PRE-CONSTRUCTION RFI LOG

PROJECT	FBCESD 5 New Fire Station Facility
ARCHITECT	Slattery Tackett
JOB #	23/779
DATE	5/24/24
	5/30/24

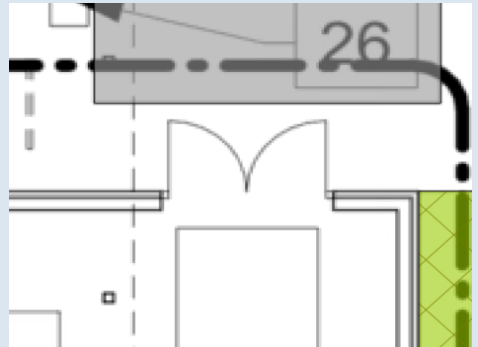
10	Finishes	There are some areas in the model that call for Stucco on metal wall panel, but those same areas call for Cement panel in the exterior elevations. Please clarify which to use.	A-201, A-202	 <p>14. CEMENT PLASTER CP-01 OVER 1 1/2" RAINSCREEN FRAMING Z-GIRTS</p>	05/30/24	05/31/24	Clarrification of question is needed. What drawing sheets state "stucco on metal wall panel" or "cement panels"? See Exterior Materials Schedule on exterior elevation sheets A-201 and A-202 for list of exterior materials. Keynotes 13 and 14 describe exterior materials attached to 1 1/2" rainscreen framing z-girts.
11	Openings	Will the four-fold overhead doors be Hurricane rated?	A-201, A-202		05/30/24	05/31/24	Four-Fold doors will not be hurricane rated, but will be rated to withstand wind loads stated on structural drawings using a modified version of the FF300 series.
12	Equipment	Fan schedule calls for a fan type F-4, but we cant locate it. Where is this fan located?	AC-101, AC-102		05/30/24	05/31/24	Fan type F-4 is located at the exterior patio area. See site plan AS-101, note 27.
